**Education Services Center
California Environmental Quality Act
Mitigated Negative Declaration**

WRITTEN COMMENTS AND RESPONSES

**ITEM 0910-006
July 2, 2009**

DRAFT MITIGATED NEGATIVE DECLARATION, FOLSOM CORDOVA UNIFIED SCHOOL DISTRICT EDUCATION SERVICES CENTER (SCH#2009062009)

BASIN OUTFALL
 (SEE SHEET 4)
DETAIL 1
 N.T.S.

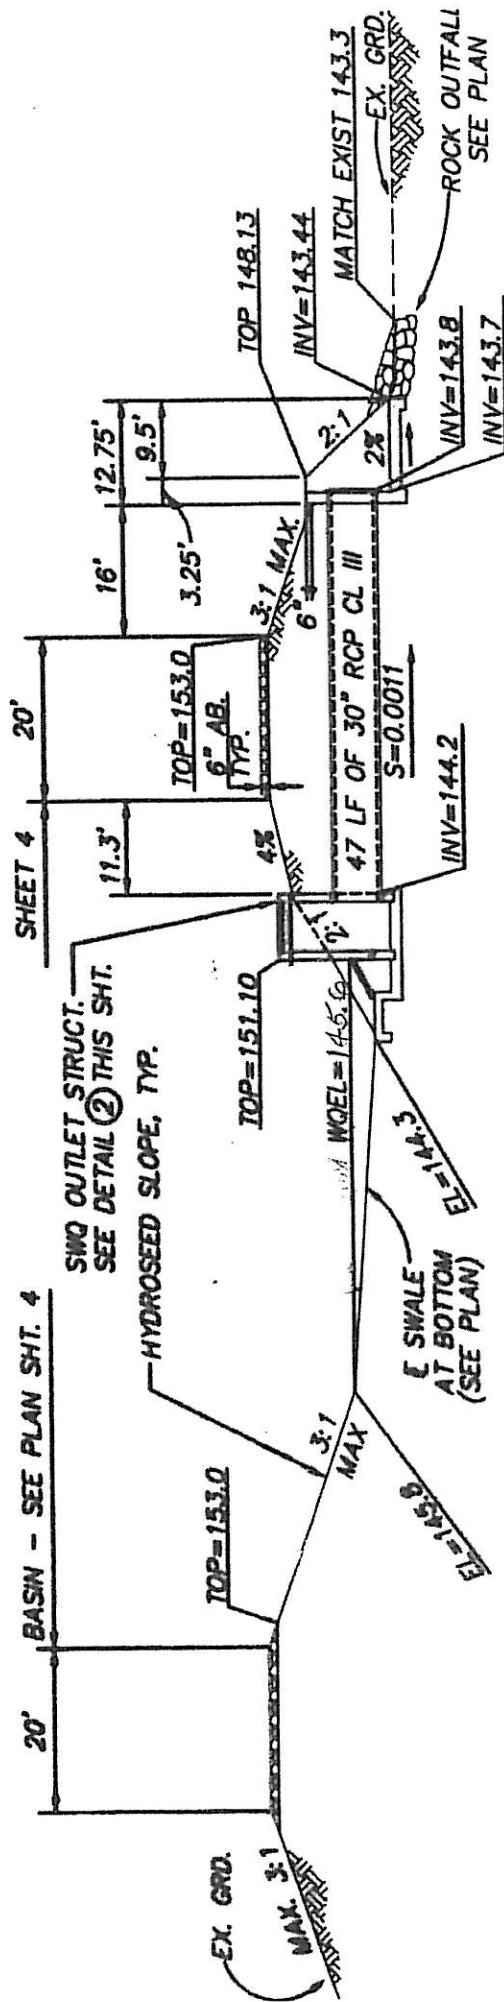
- a) There is no discussion on the design and operation of the stormwater retention basin, nor is there a discussion of the construction of an outfall from the detention basin to Alder Creek. This information will need to be supplied as supplement of your application for a 404 Permit/401 Water Quality Certification. Without that information, the application cannot be deemed to be complete. A brief discussion of the design and operation of the basin should be provided in the Mitigated Negative Declaration. The need for a 404 Permit and associated 401 Water Quality Certification is also not discussed in the document.

1. a) The storm water quality detention basin was designed for the proposed FCUSD Administration Services Center project in accordance with Sacramento County requirements for such facilities. The basic components of it are an inlet, the basin itself, an access road for maintenance vehicles, and an outlet structure.

The inlet is a 24" reinforced concrete pipe (RCP), which provides a connection between a temporary swale and the basin (Detail 1, attached). The swale collects runoff from the school site, and drains water to the 24" RCP. The 24" RCP in turn drains the runoff into the basin. The invert of the 24" inlet pipe is set approximately 2.3 feet above the bottom of the basin to allow for sediment storage. A trash rack is to be installed on the end of the 24" RCP at the swale so as to insure that trash does not find its way into the pipe and clog it.

The outlet structure consists of three main components, a drop inlet located within the basin, an outfall structure, and a 30" diameter RCP extending through the sidewall of the basin connecting the inlet to the outfall. A detail of the outlet structure is attached for reference. The inlet serves as a metering device for the discharge of the water stored within the basin. County design standards require that 75% of the stored volume drains from the basin within a minimum of 24 hours and that the entire volume drains from the basin within a maximum of 48 hours. The inlet has a small diameter hole in its wall at its base with an orifice plate over a portion of the hole. A small diameter hole in the plate allows water to flow into the inlet, which then drains into the 30" RCP, and then eventually out of the basin through the outfall structure. The water drains onto natural ground, and the existing topography directs the flow to Alder Creek.

Curve for Maximized Detention Volume P₀	Date: August 2006
	Figure: E-3

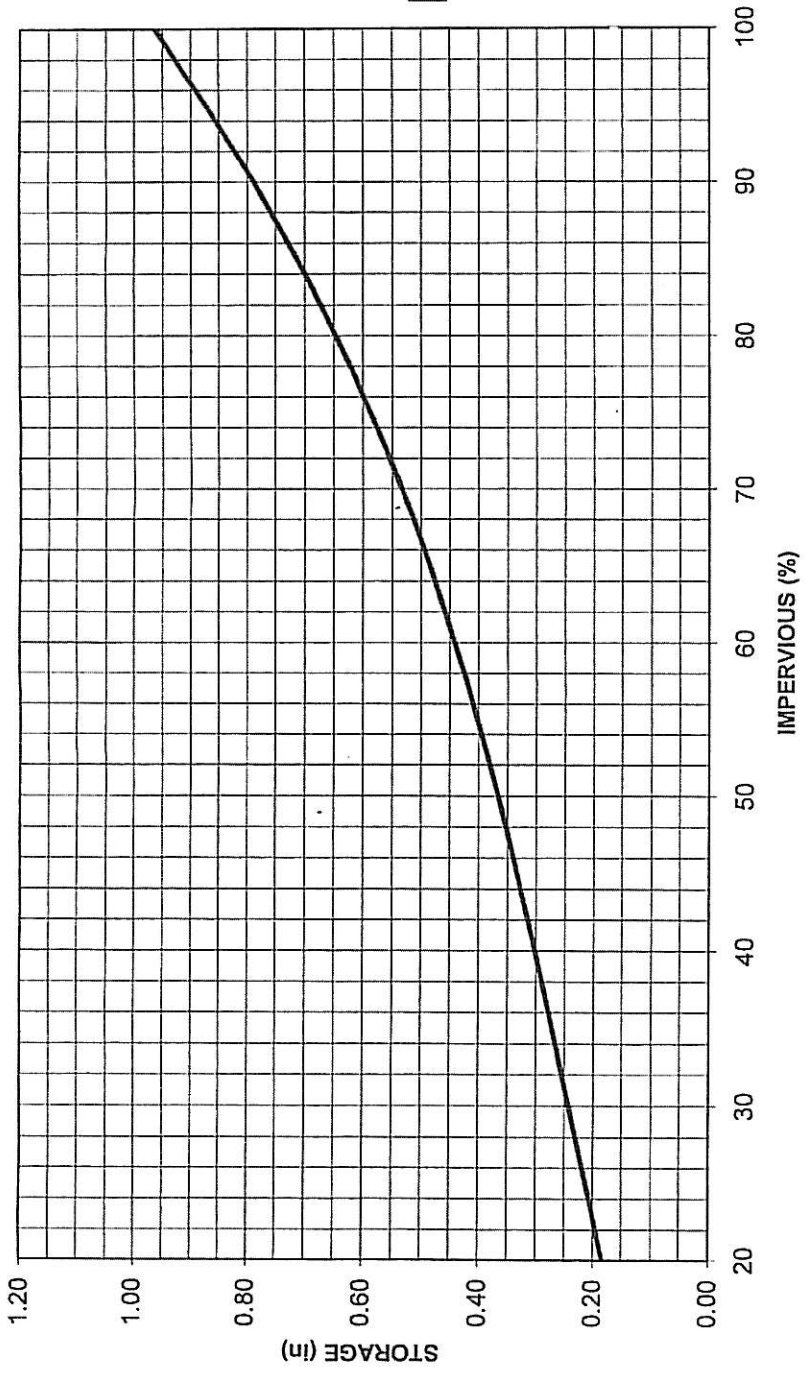
- c) The project includes a stormwater swale and stormwater quality retention basin to help treat stormwater pollutants that are picked up by rainwater flowing from the office complex site. Eventually the stormwater swale will be replaced by an underground pipe negating the positive aspects for water improving water quality runoff provided by the vegetated swale. Is the retention basin itself sufficient to provide the water quality aspects needed to reduce the flow of pollutants in stormwater runoff from the project?

1. c) The primary purpose of the temporary swale is to collect runoff from the project site, and transport it to the storm water quality detention basin (Curve for maximized Detention Volume P_0 , attached). The positive aspect of the runoff flowing through the swale is only a secondary benefit, and is not necessary to meet the storm water quality requirements for the school site project. The storm water quality detention basin is designed in accordance with County standards to meet the storm water quality requirements of the project by itself. More specifically, the basin is sized using the "Sacramento County Volume-Based Design Method". The basic equation used is:

$$WQV(\text{Ac-ft}) = (P_0)A/12$$

'A' is the drainage shed area in acres. ' P_0 ' is the "Maximized Detention Volume" in inches for the drainage shed, and is determined from the attached Figure E-3. For the project, ' P_0 ' is 0.55" for a % impervious of 71%. 'A' is 6 acres. Using these values, the required volume calculates out to 0.28 Ac-ft, which the basin is designed to store.
